APPEAL SUMMARY

Appeal ID: 22218	Project Address: 426 SW Harvey Milk St
Hearing Date: 12/11/19	Appellant Name: Cassandra Tyler
Case No.: B-018	Appellant Phone: 503-847-2183
Appeal Type: Building	Plans Examiner/Inspector: Brian Quattlebaum
Project Type: commercial	Stories: 10 Occupancy: B Construction Type: II-B
Building/Business Name: Urban Renaissance Group LLC	Fire Sprinklers: Yes - All
Appeal Involves: Alteration of an existing structure, Reconsideration of appeal	LUR or Permit Application No.:
Plan Submitted Option: pdf [File 1]	Proposed use: Office Core & Shell Renovation

J.K. GILL CORE & SHELL
RENOVATION

CODE
COMPLIANCE
PLAN - LEVEL 01

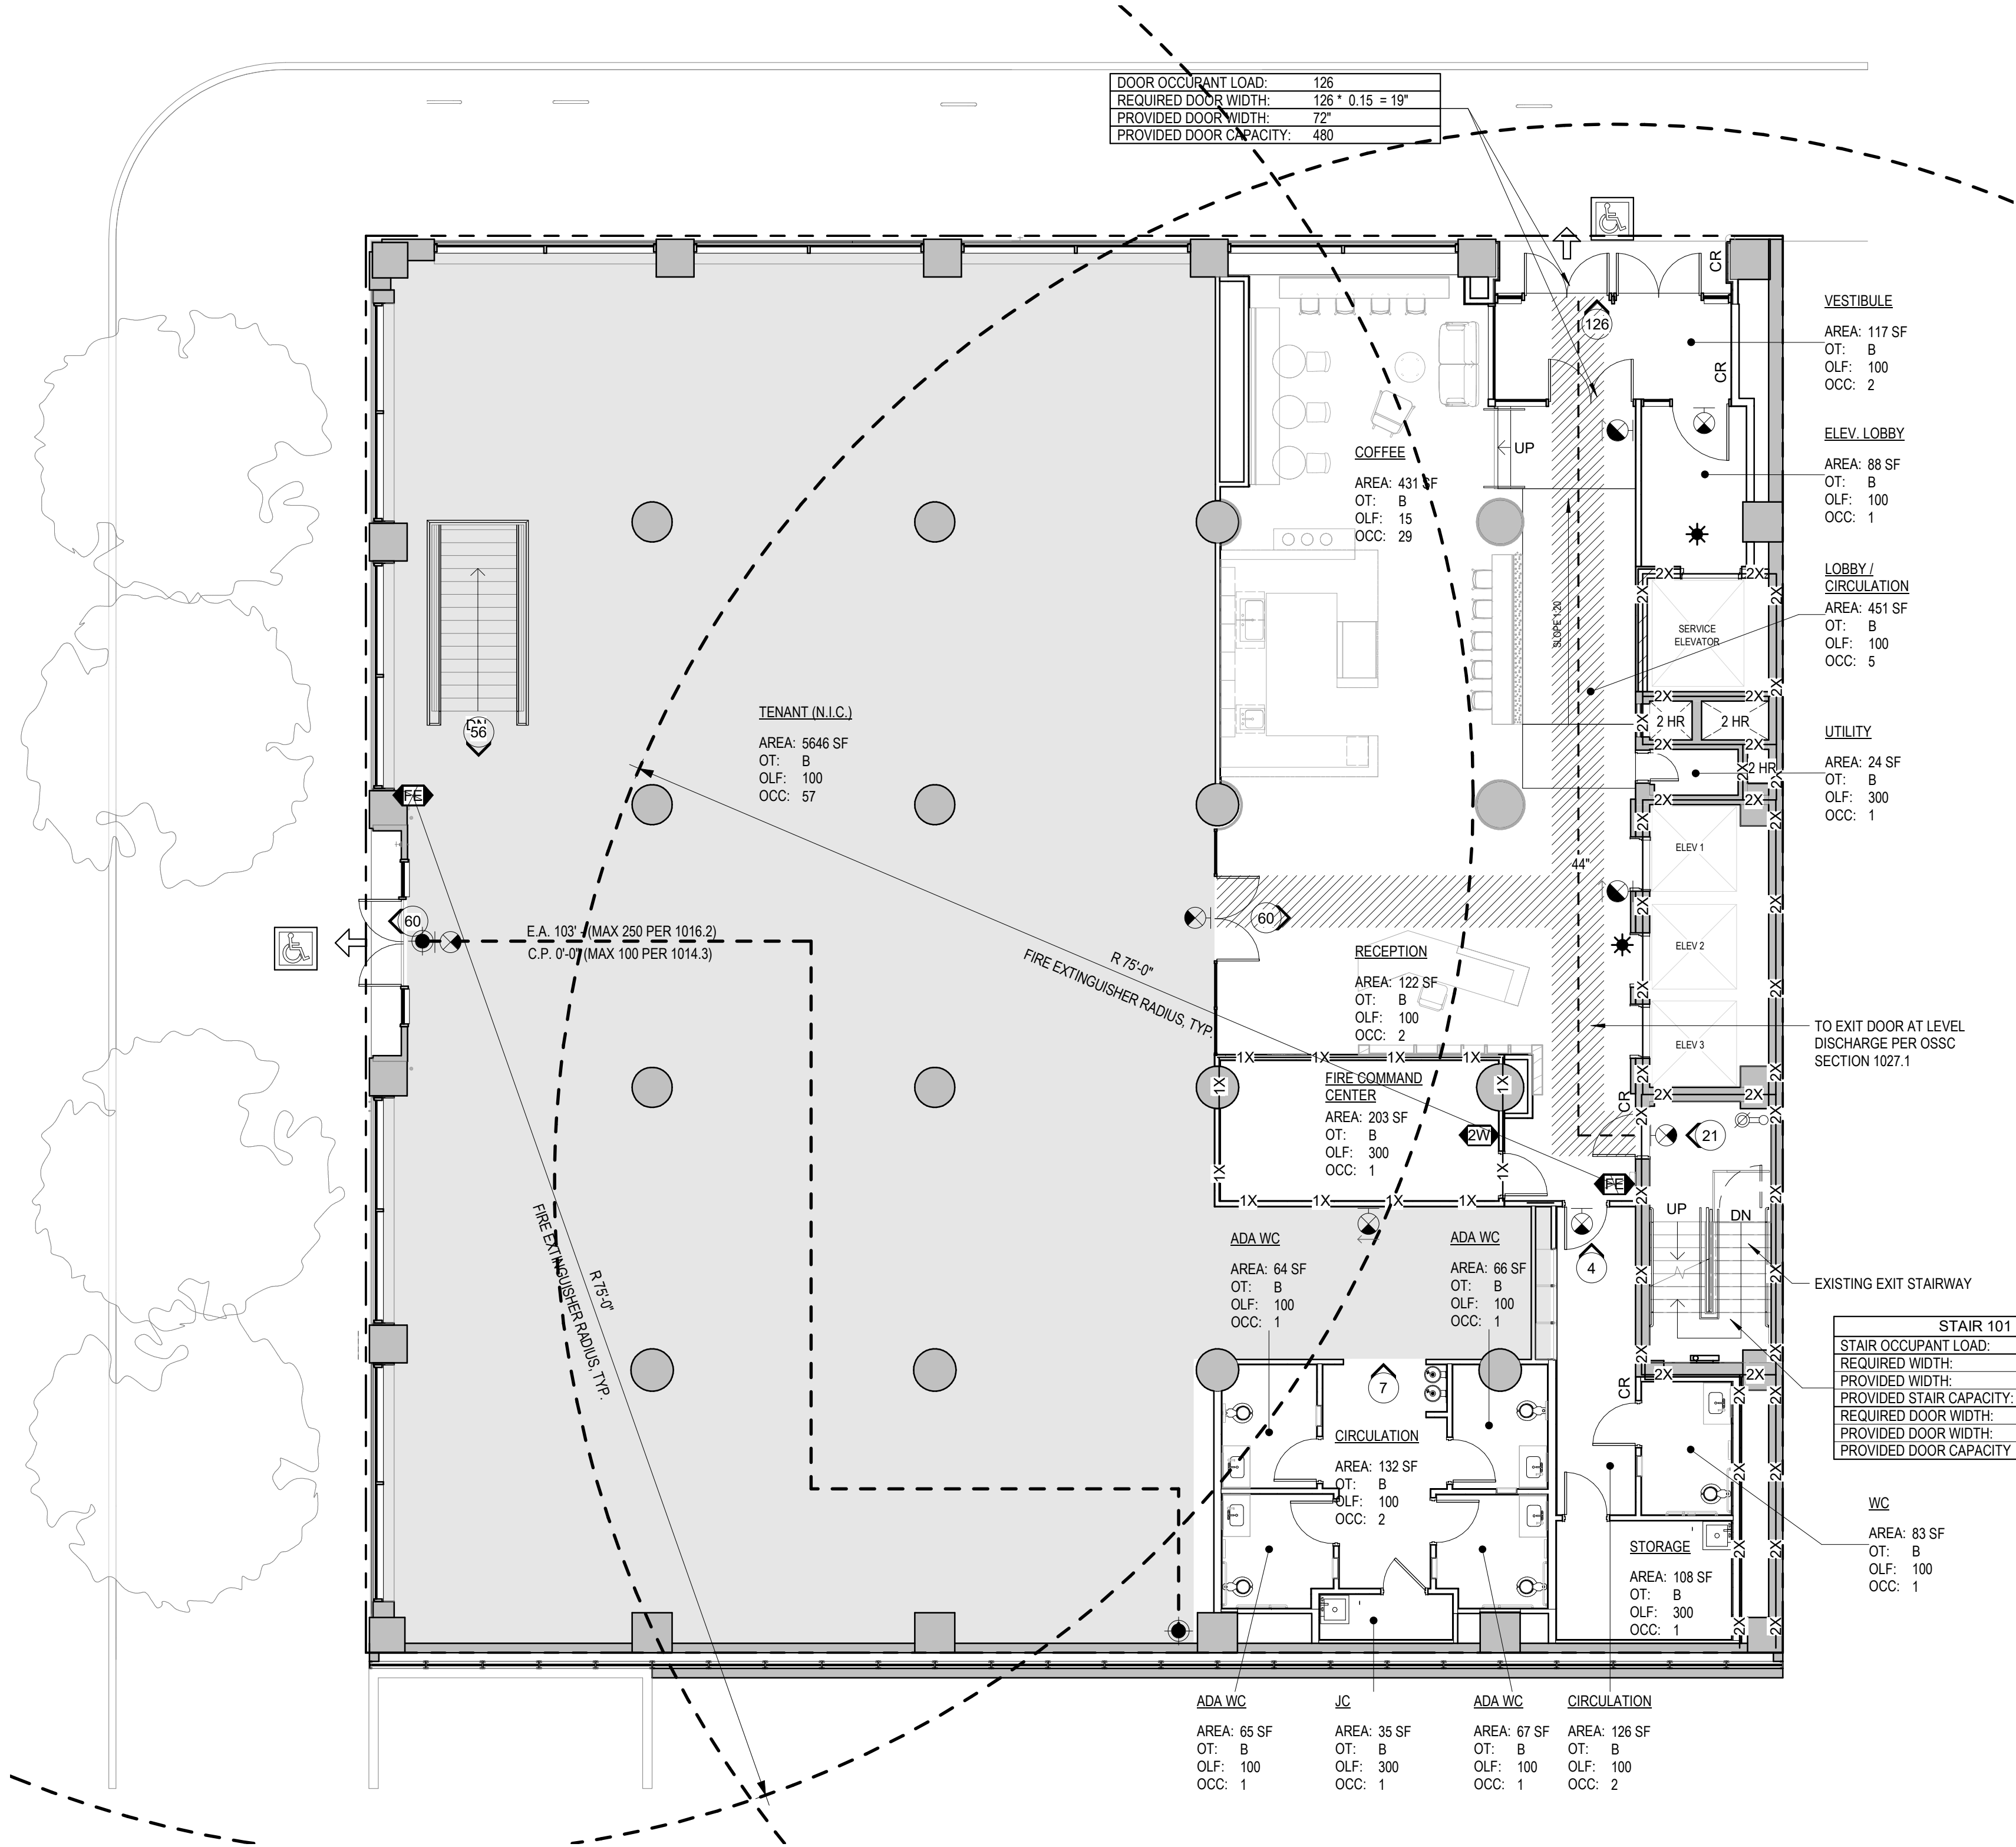
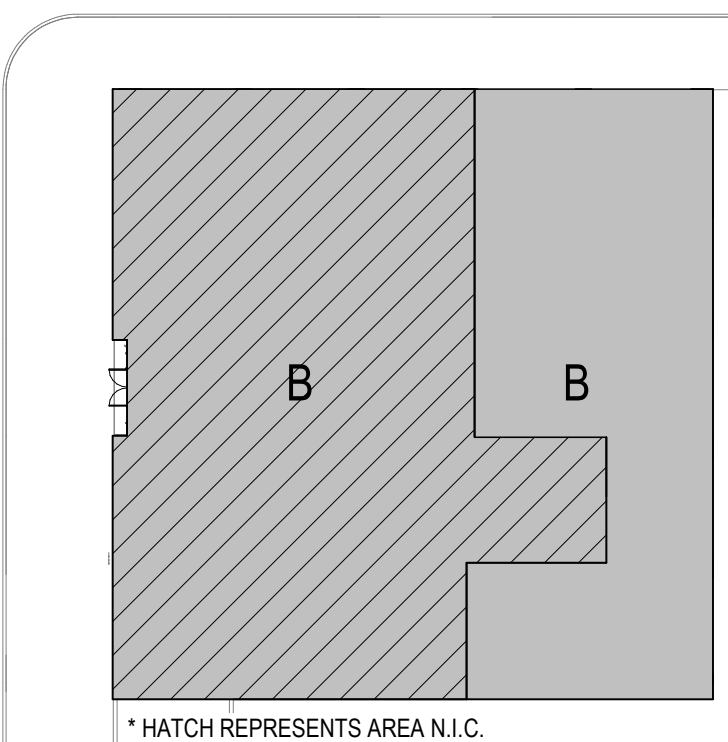
Proposed Design The project proposes to delay rounding the required number of fixtures until combining the minimum required per sex since the project is providing private individual non-gender specific bathrooms to satisfy the minimum plumbing requirements. The only floor where this is different than rounding prior to combining the minimum per gender is the ground floor of the project.

Ground Floor:

B occupancy is 116 occupants = 58 male and 58 female

58 male = 2.32 wc 58 female = 2.32 wc Combined = 4.64, project will provide 5 single user restrooms.

1. Alternate calculation of plumbing fixtures: Granted provided occupant loads are confirmed at time of tenant improvements.

CODE COMPLIANCE PLAN - LEVEL 01
G101

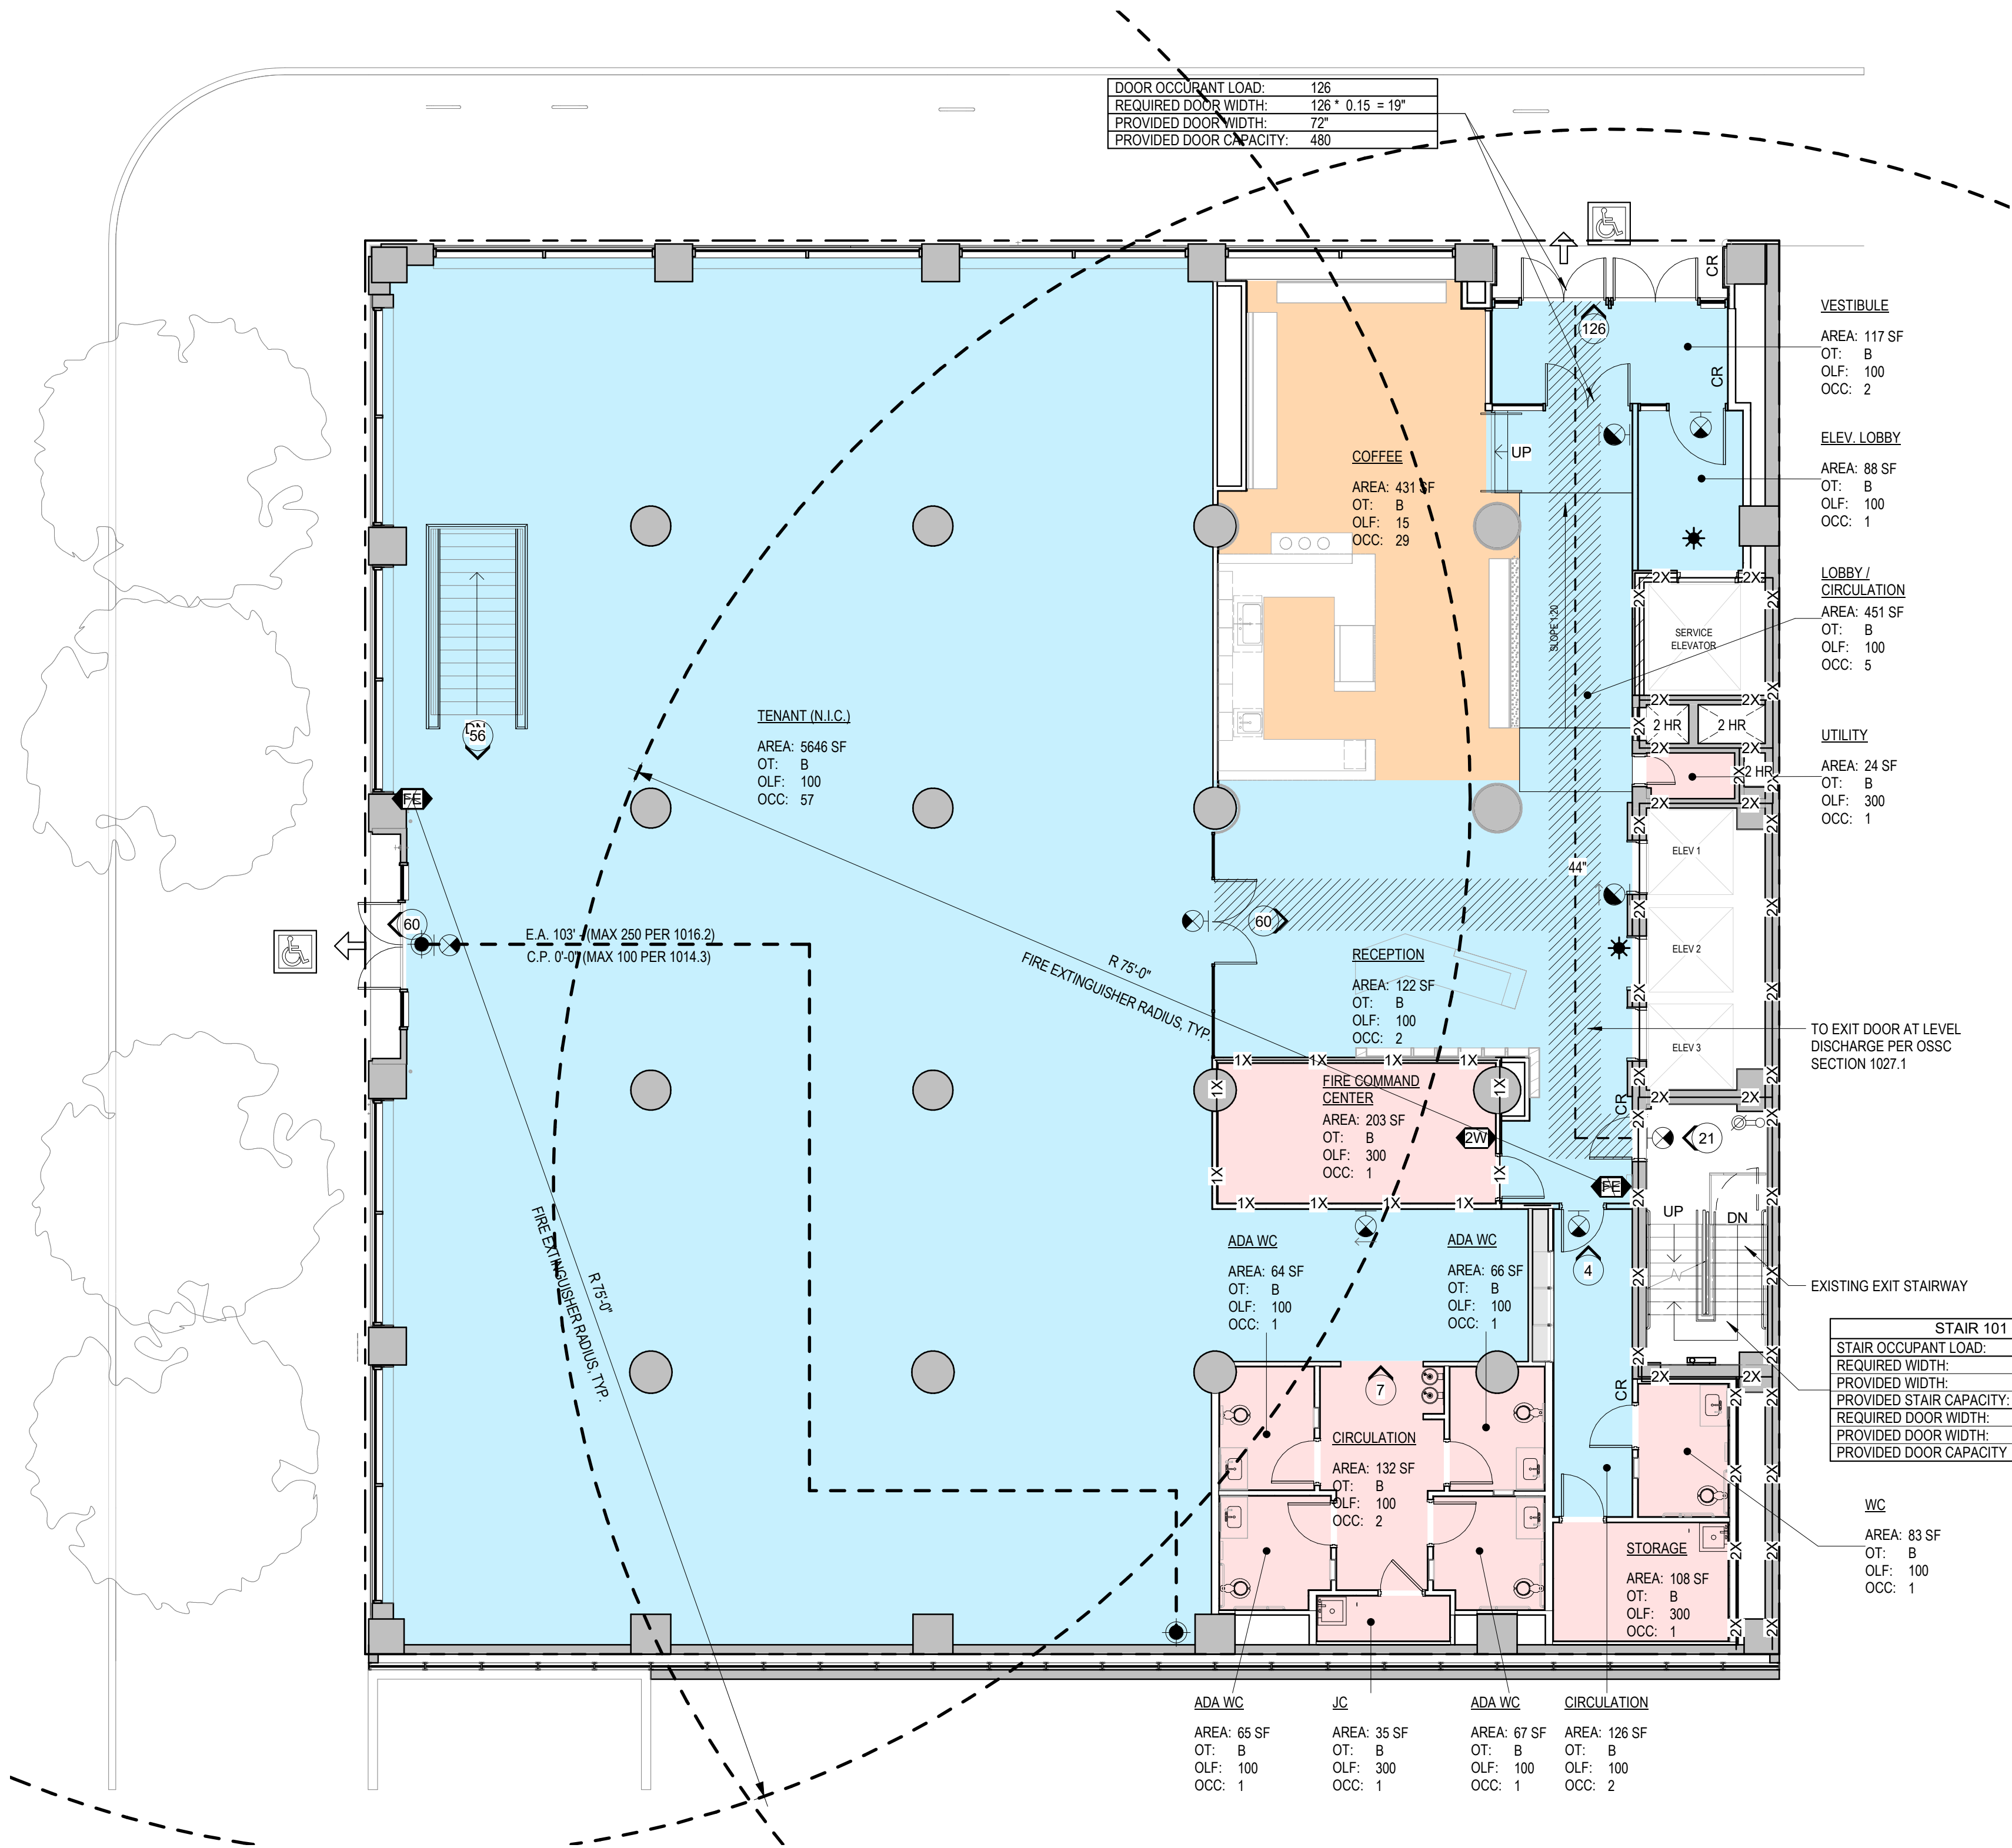
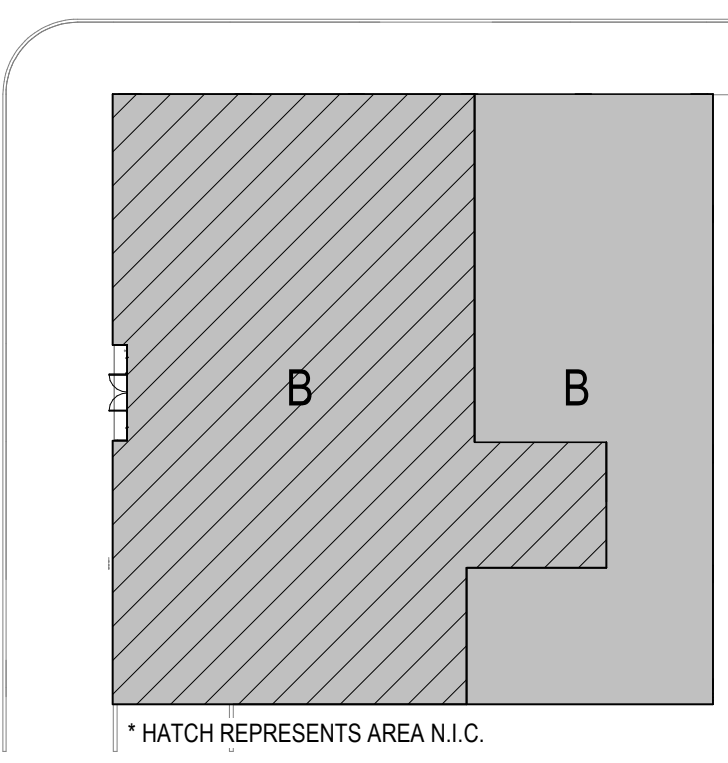
Proposed Design The project proposes to have (1) ADA compliant private non-gendered restroom facing the coffee shop and lobby, with the remaining required minimum fixtures for the ground floor located in the tenant space. See attached ground floor code plan.

[Reconsideration text] See attached color coded ground floor plan and building plumbing summary table. The plan defines the areas the project considers to be accessed by the public and clarifies the spaces that are tenant circulation for tenants headed to and from floors where they have access to their tenant restrooms. The plumbing summary table illustrates the excess fixture capacity in tenant spaces on all typical floors. Tenants also have access to the basement locker room facilities that are a non-simultaneous use with their tenant spaces. Physical seating in the coffee shop will only accommodate 18 persons seated. Assuming two employees, and a receptionist, there would need to realistically be 9 people standing in the coffee shop to hit the threshold of 30 people accessing the floor restroom as permitted by the interpretation.

Reason for alternative The coffee shop will be predominantly a to-go establishment serving mainly building occupants. The to-go tenants and visitors will have access to restrooms on their destination tenant floors and/or the facilities in the basement and will not be lingering in the lobby or coffee shop. The lobby and circulation occupants (non-coffee shop) are transient occupants en route to or from their offices on other floors. There is no lobby seating or areas for congregating outside of the limited seating in the coffee shop, so all lobby and circulation occupants will just be passing through. The project requests to use the interpretation from <https://www.portlandoregon.gov/bds/article/515318> to accommodate the public facing coffee shop occupancy of 30 persons max, with one ADA compliant restroom, while accommodating the transient occupancy load with facilities in the tenant area on the ground floor, as well as the destination tenant floors, as non-simultaneous use.

Knowing the occupancy of the coffee shop will never exceed 30, and that restrooms are located in tenant spaces to accommodate the full occupant load of the building, the proposed design does not reduce the health or accessibility of the space, and has no impact to structural, energy conservation, life safety or fire protection.

2. Access to Level 1 toilet facilities: Granted provided occupant loads are confirmed at time of tenant improvements.
